## Chatswood Chase Shopping Centre

### Flood Modelling Report - Addendum

- Flood modelling report (Revision F) was issued as part of a DA submission to council for development of Chatswood Chase Shopping Centre. Council ref: DA-2022/305 ePlanning Portal ref: PAN-257802

- Council has provided a request for additional information (refer letter dated 24/01/2023) in regard to the DA with specific requests in response to the flood report.

Overland Flow Path

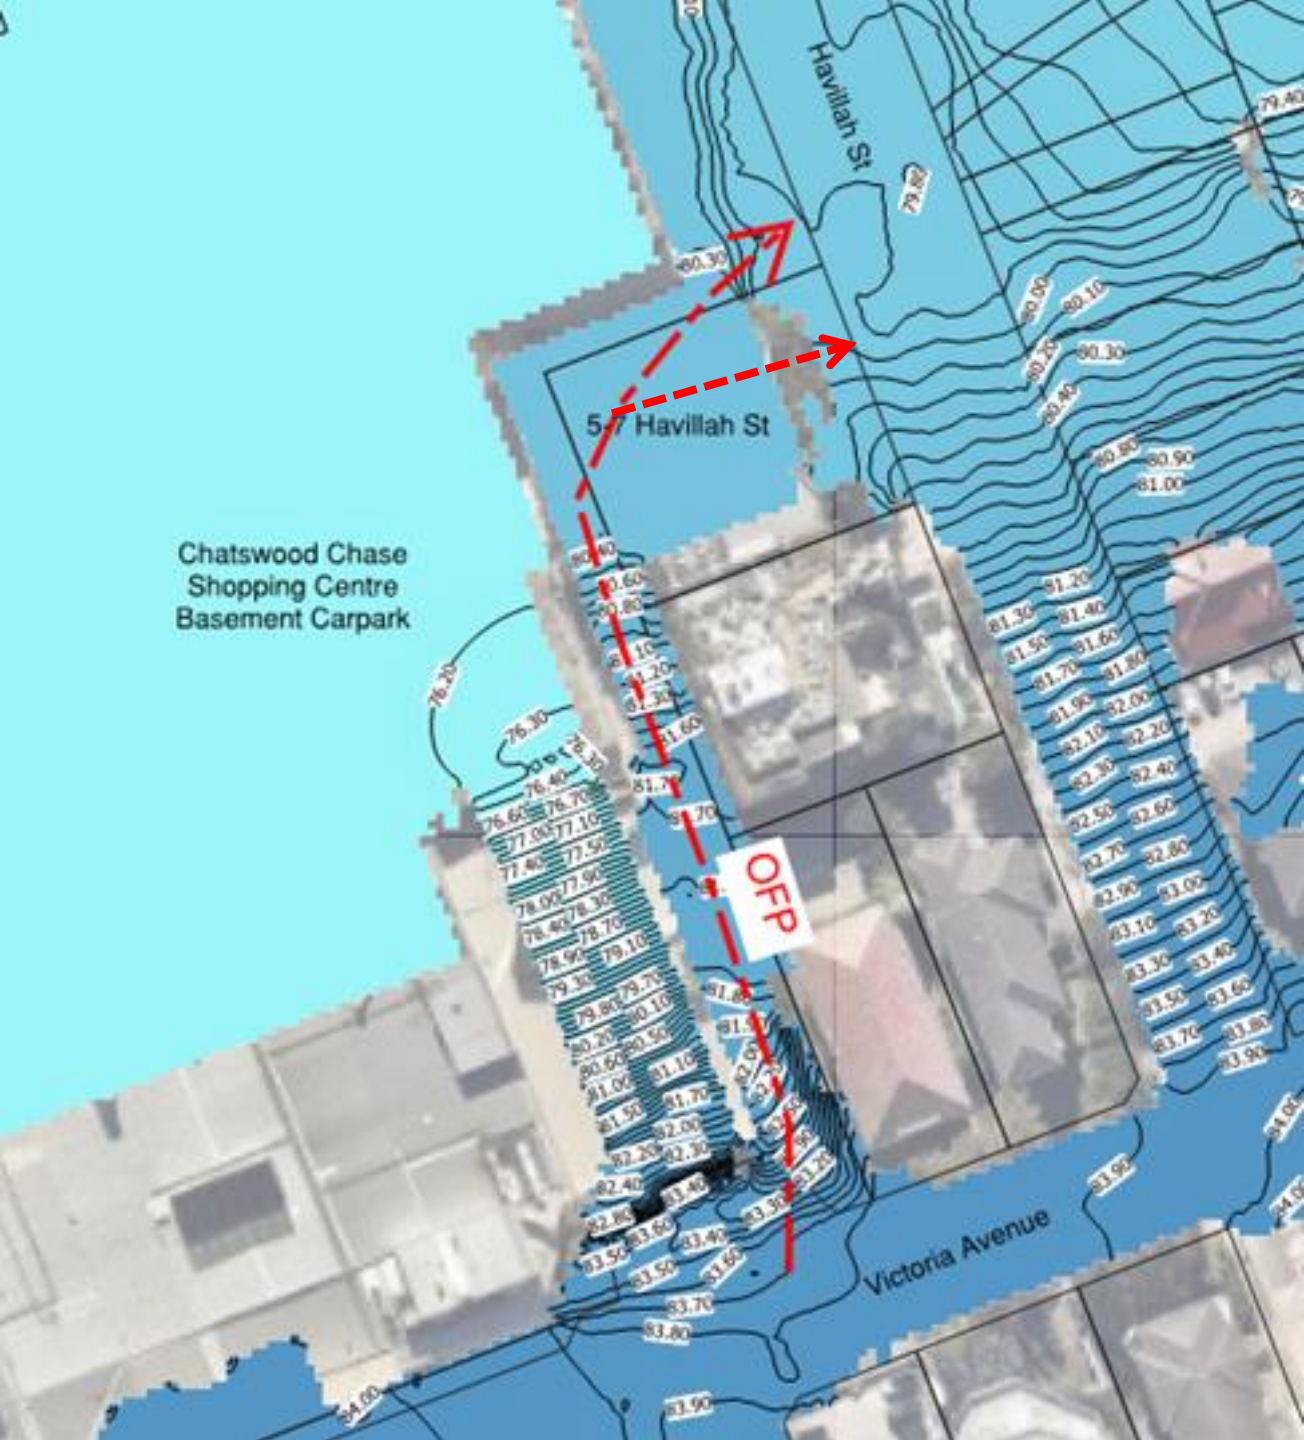
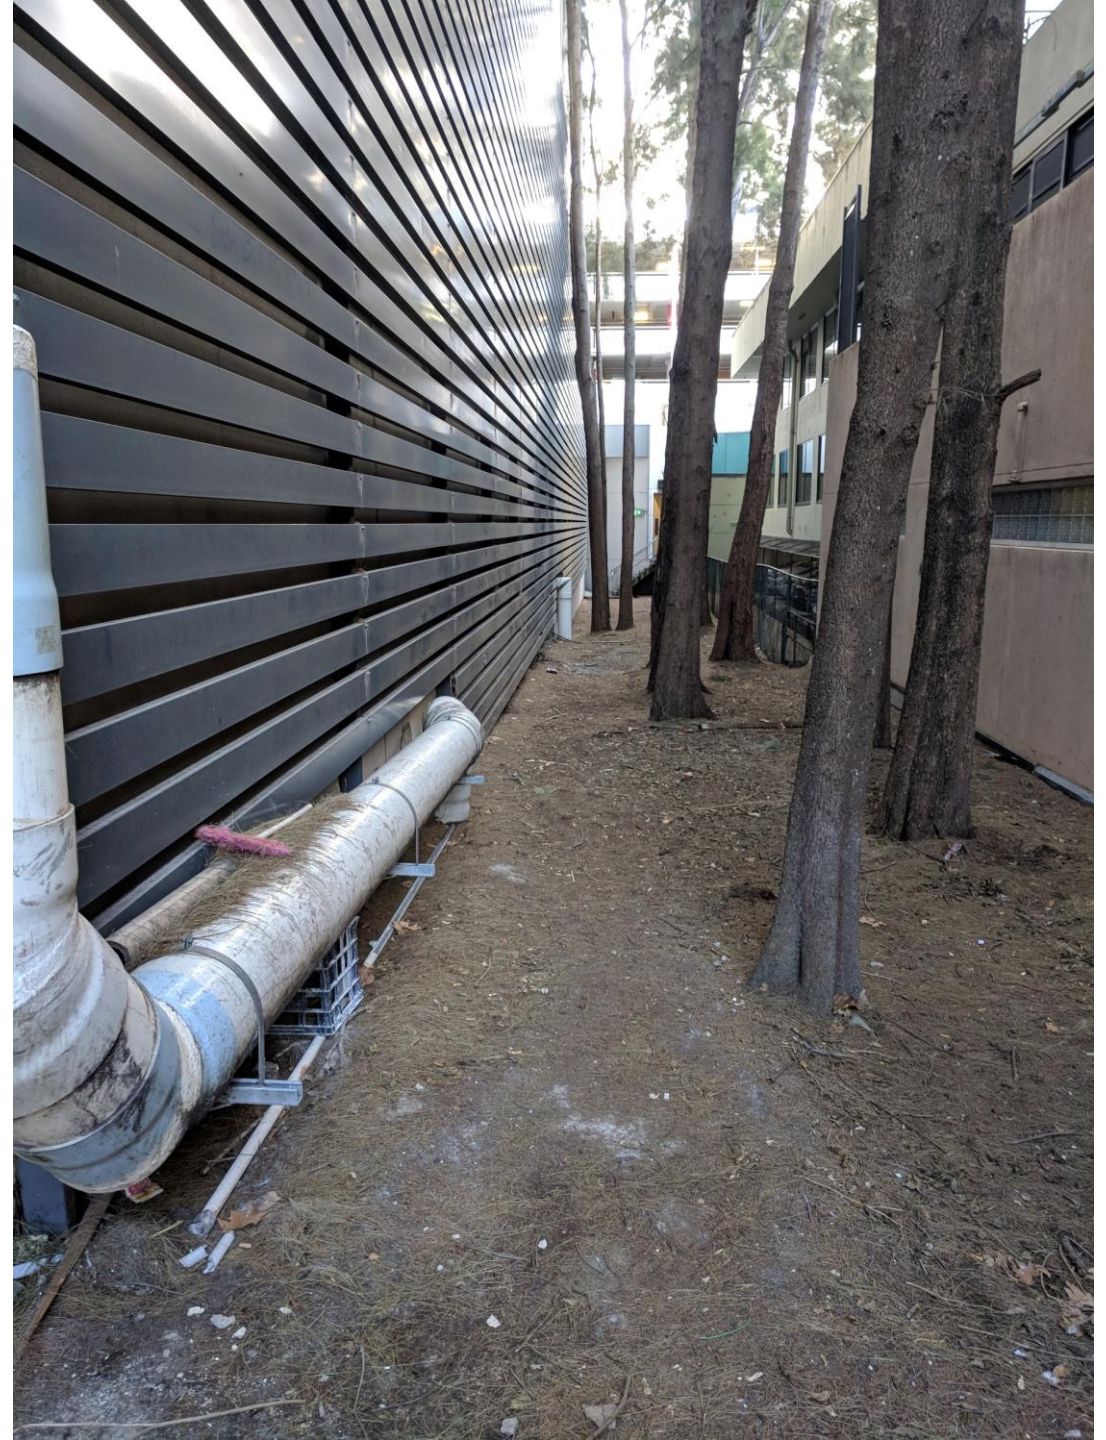
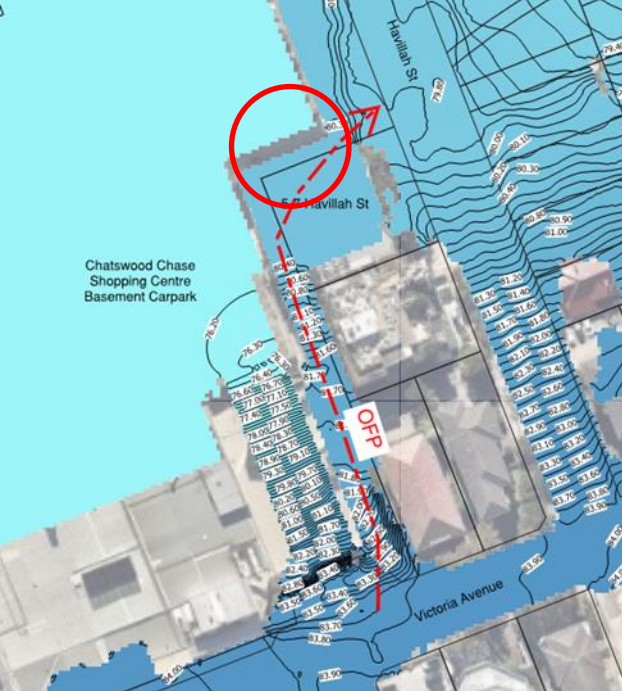
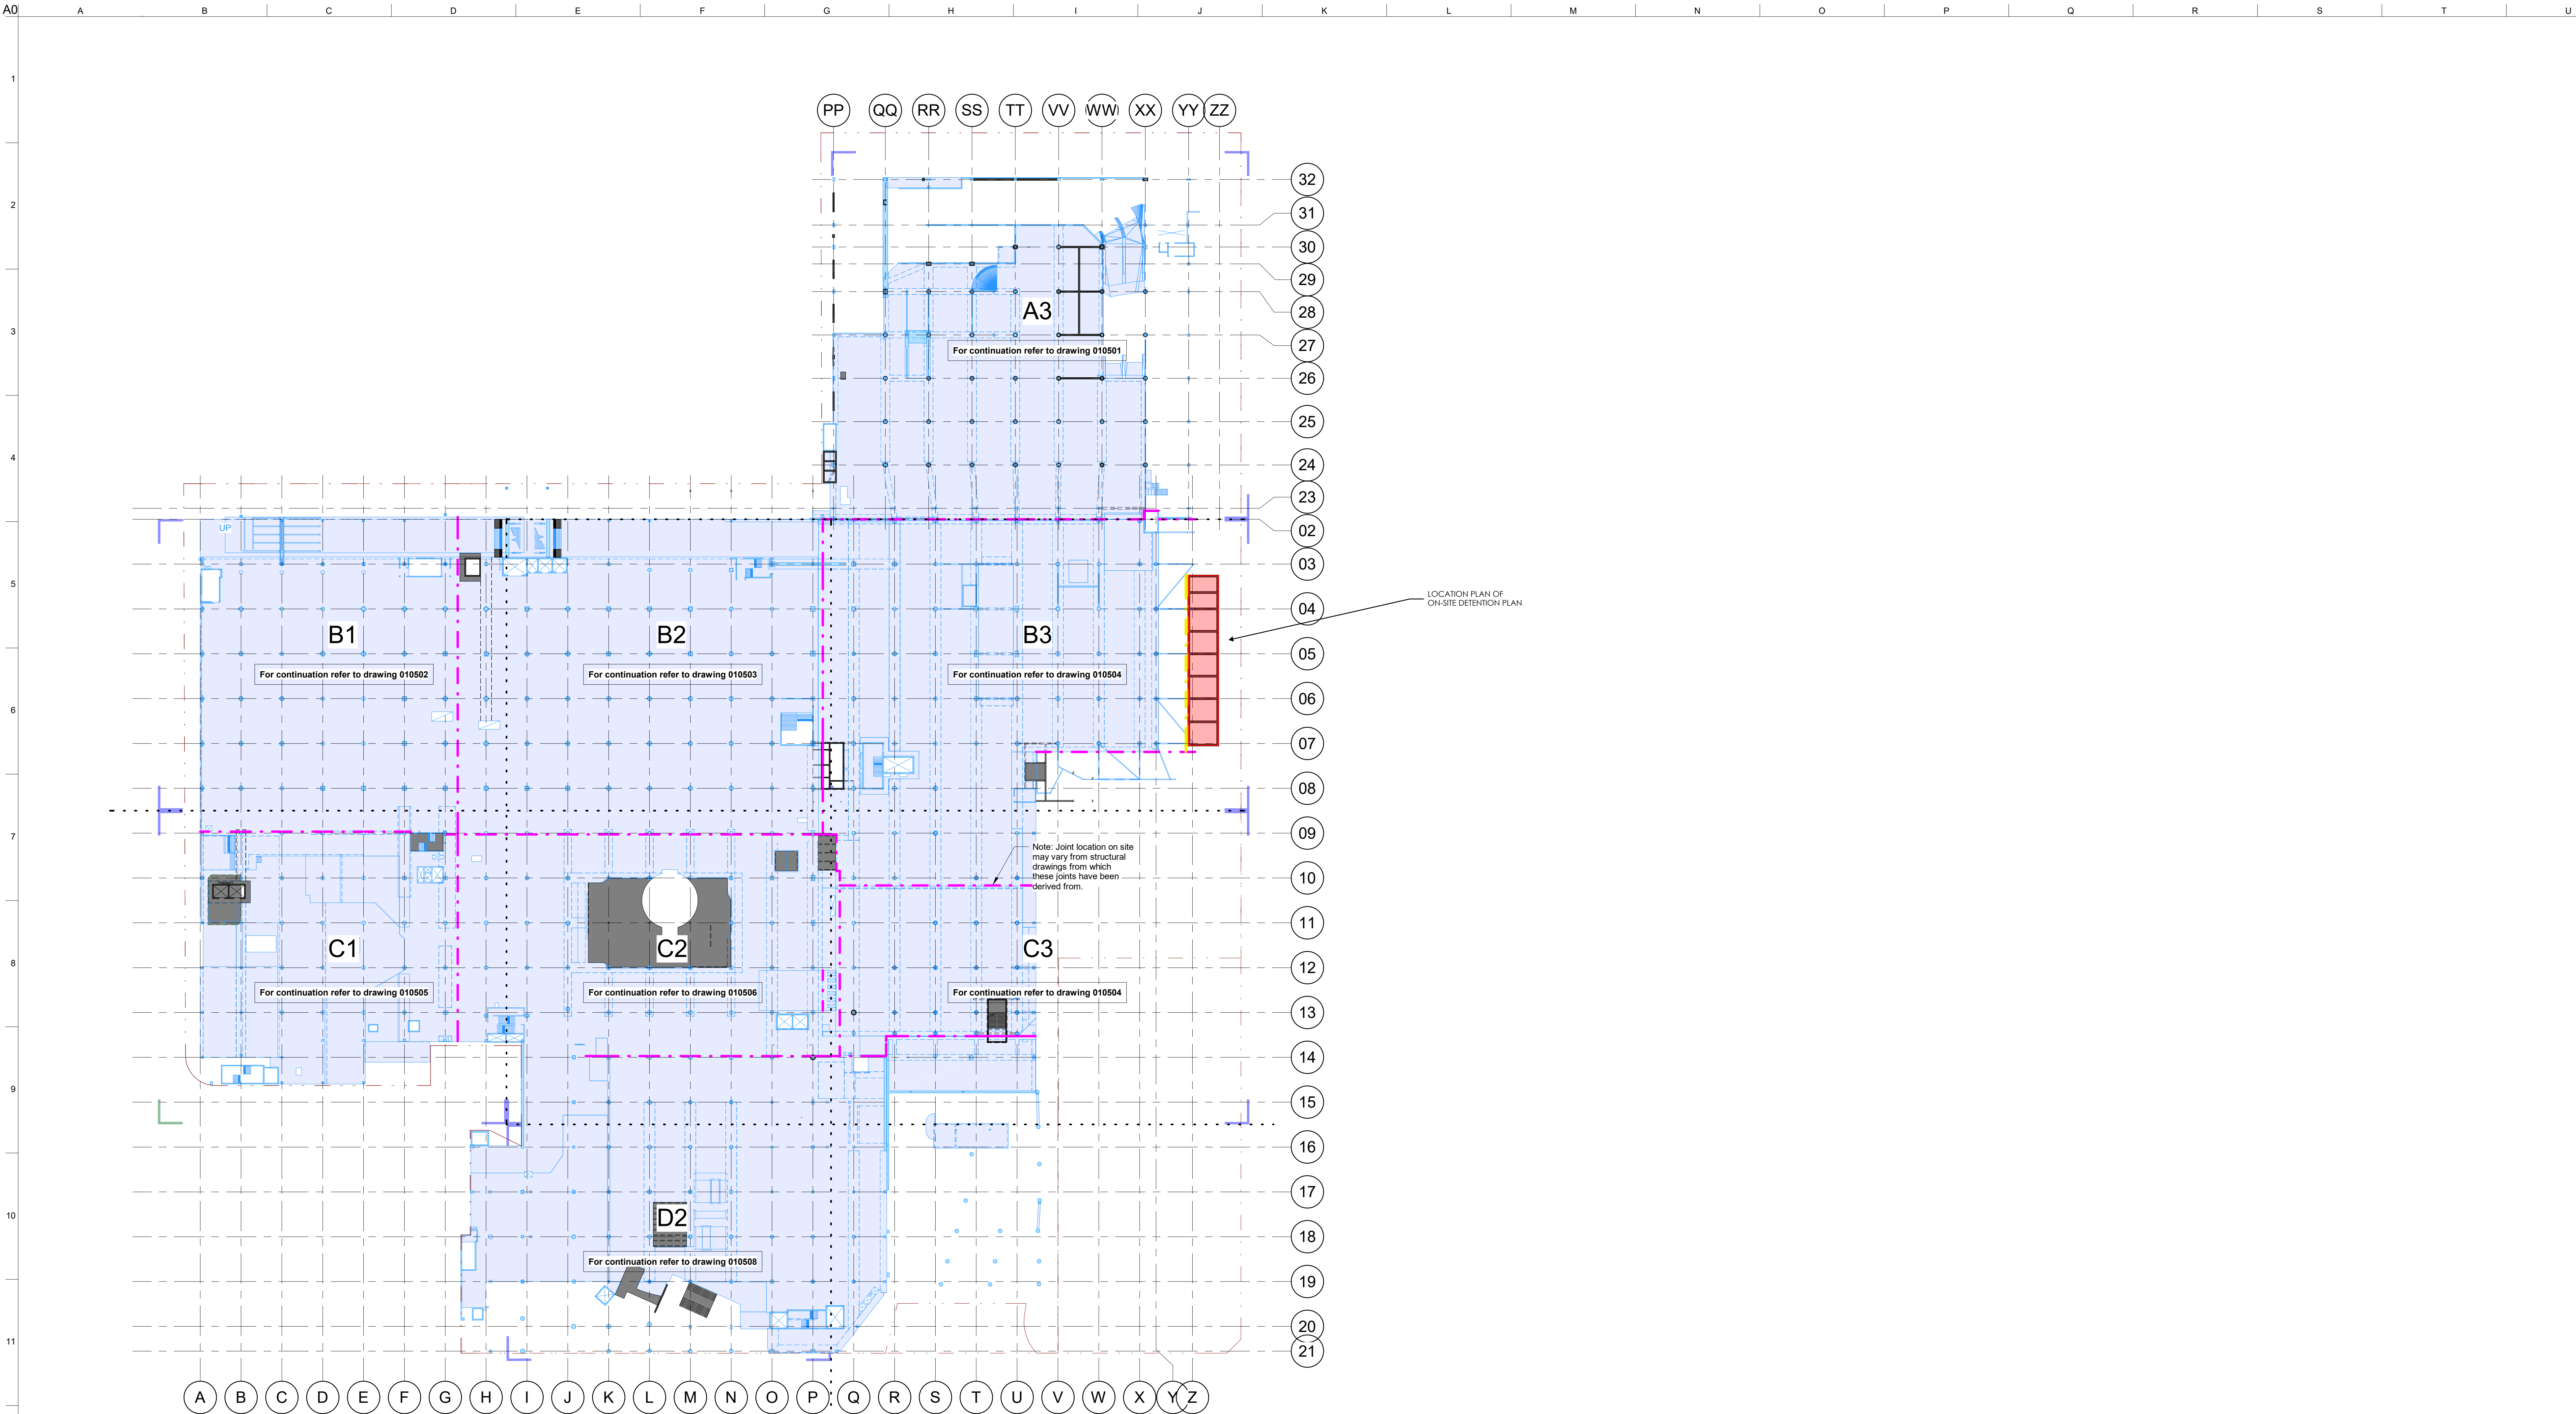
*Item 12k - Details of how the overland flow will be conveyed along the boundary of 345 Victoria Avenue and Havilah Street properties.*

Currently, excess overland flow from the low point on Victoria Avenue, not catered for in the council drainage system, flows into the Chatswood Chase Shopping Centre (CCSC) basement carpark. There is also a portion of the flow following an overland flow path, which takes water down the CCSC loading dock entry ramp, which is bounded by a parapet wall on one side and an embankment and fence at the rear of the Havilah Street properties. In some higher flow events a portion of overland flow passes through to Havilah Street via a carpark at the rear of properties on the corner of Victoria Avenue and Havilah Street. The majority of the flow then continues into the loading dock itself where some flow enters the basement carpark via a ramp from the loading dock, and the remainder of the flow continues overland along the boundary of the shopping centre until it reaches the rear of 5-7 Havilah Street where it predominantly flows through the rear of the carpark below the building and out onto Havilah Street. There is also a minor flow path (approximately 1.5m in width) around the perimeter of this building which also allows flow out onto Havilah Street. This is the existing condition.

In the proposed design, automatic flood gates will control the entry of water into the CCSC basement carpark, using a flood level control switch located in the basement which automatically triggers the gates when the water level is approximately 200mm in depth. This prevents water from entering the CCSC basement carpark greatly reducing hazard levels and risks, and the majority of excess stormwater will be diverted down the loading dock entry

ramp. A one-meter wall is proposed on the boundary to prevent minor flows through the carpark at the rear of the properties on the corner of Victoria Avenue and Havilah Street and manual flood gates are proposed to prevent flow from entering the loading dock (and thus preventing flow to the basement via this route). This contains the overland flow path to the boundary of the shopping centre bounded by the external shopping centre wall and the walls of the buildings on Havilah St. Although in high flow events, a portion of overland flow does pass through to Havilah Street via the carpark upstream of 1-3 Havilah Street, overtopping the proposed 1m wall. Again, the remaining flow will enter the rear of the 5-7 Havilah Street carpark below the building where we have proposed an updated garage door / gate with 1m solid panel at base or equivalent on the carpark entry. The purpose of the 1m panel is to retard the flow onto Havilah Street and provide a level of temporary storage to prevent unacceptable afflux downstream of Havilah St in the residential area. Water from the 5-7 carpark can drain to Havilah Street via the minor overland flow path around the perimeter of the building. Flow can also exit the carpark directly to the minor overland flow path via large openings along the NW side of the carpark. In high flow events water will overtop the 1m flood barrier in the carpark entry at 5-7 Havilah Street and exit the carpark into Havilah Street.

It should be noted that the property at 5-7 Havilah Street is owned by Vicinity and the risks to life and property due to increased flood levels are far less than the risks associated with the alternative, which is to allow the CCSC carpark to flood. The risks within this smaller carpark will be managed as part of the flood management plan which will include removal of all vehicles and deployment of the 1m flood barrier / garage door (refer attached plan – MAKE Drawing AR-MAK-DRG-DA1200) when the other manual flood barriers are triggered within the centre.

Refer to attached photos of overland flow path.
